UNITED STATES PATENT AND TRADEMARK OFFICE

APPLICATION NO.	FILING DATE	FIRST NAMED INVENTOR	ATTORNEY DOCKET NO.	CONFIRMATION NO.
09/841,402	04/23/2001	Robert D. Kluser	7201 US	6386

Office Action Summary	Application No.	Applicant(s)	
	09/841,402	KLUSER ET AL.	
	Examiner Janet M. Wilkens	Art Unit 3637

FIG. 2

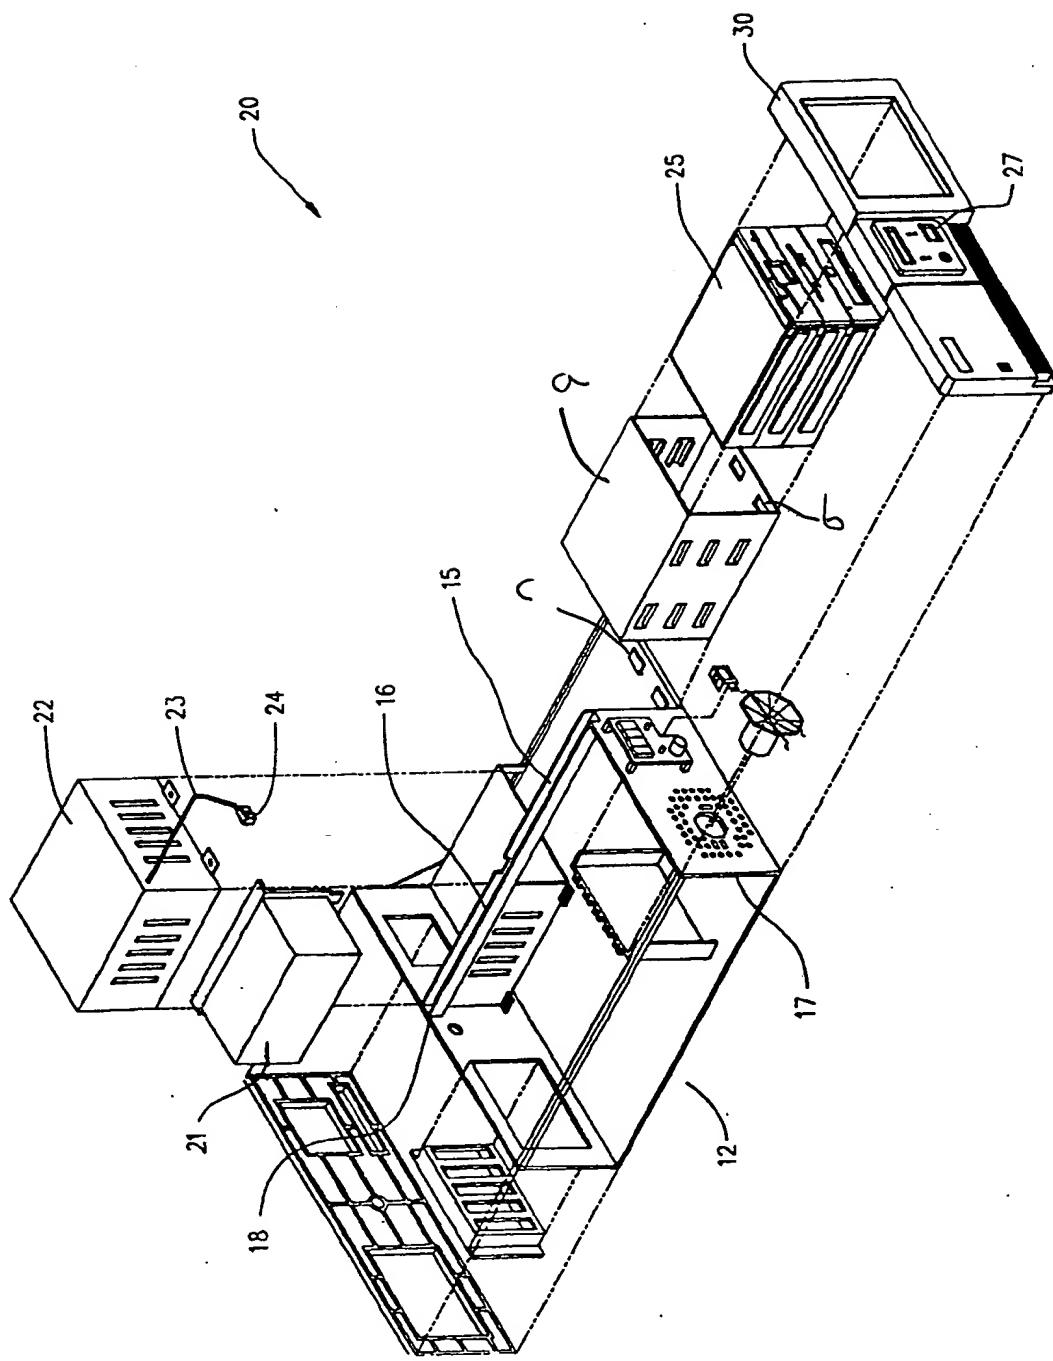
Claim 1 and 4 are rejected under 35 U.S.C. 102(b) as being anticipated by Rodriguez. Rodriguez teaches a rack-mounting system (Fig. 2) comprising: a frame forming a central compartment (entire inside of housing 20) and including a central rib (15), a sleeve (a; see Attachment A) adapted to receive an instrument and fit into the

compartment (conceivably anywhere inside the frame) and means for detachably securing the sleeve within the frame (b,c; see attachment A).
